# Dimming Ballasts

## Additional Test Data and Comments Regarding CEC Staff Report for Dimming Ballasts

**14-AAER-01**

Submitted: October 27, 2014

Figure 1. Plot of CA IOU test results from 2-lamp T5 and T8 ballasts.

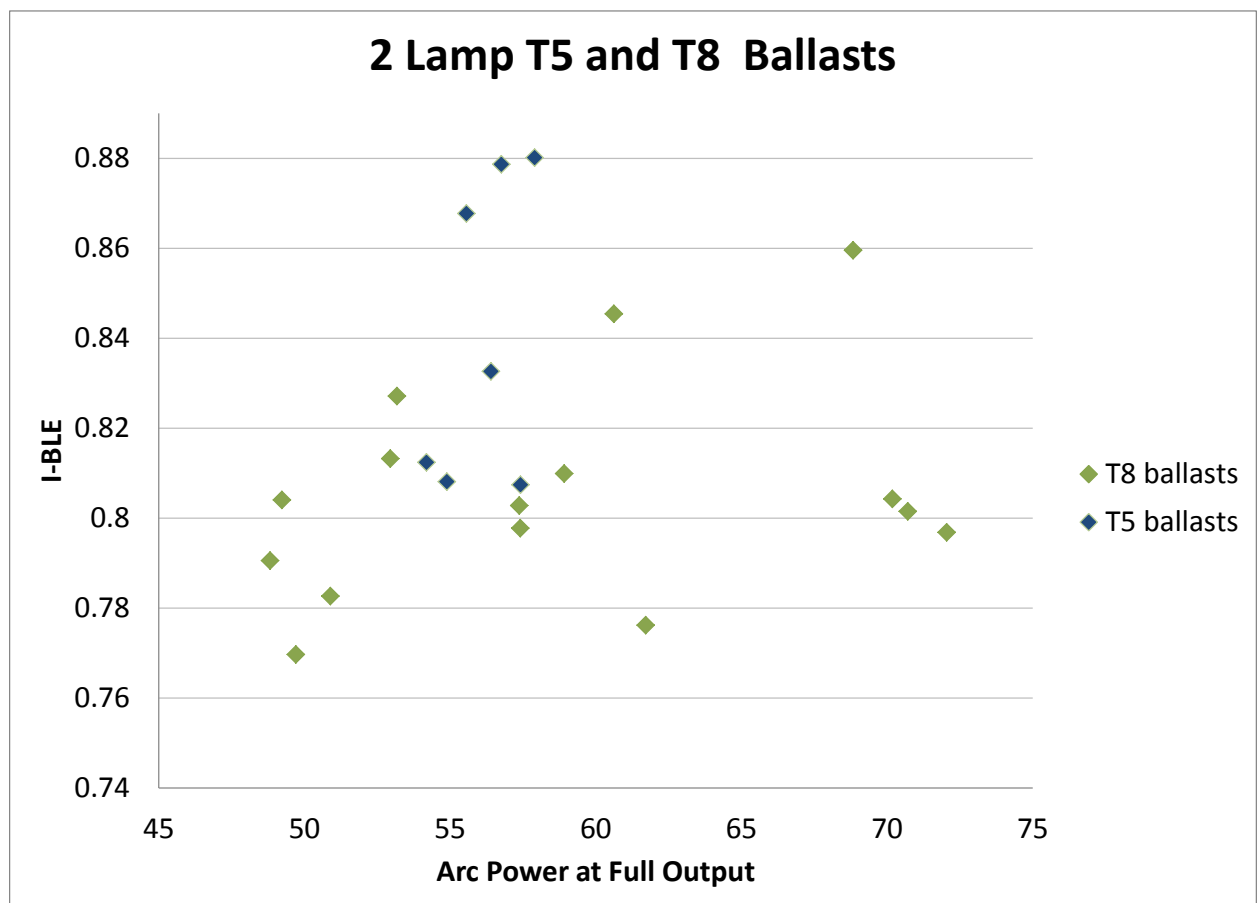
As illustrated in the chart, three of the T5 ballasts tested are more efficient than any of the T8 ballasts tested. These results imply that T5 ballasts can be at least as efficient as T8 ballasts designed to operate the same number of lamps (and/or at the same arc power), and therefore, it would be appropriate to apply the standard level proposed for T8 ballasts to T5 ballasts as well. The full test results from the 2-lamp T5 testing are included for docket as a separate Excel file.
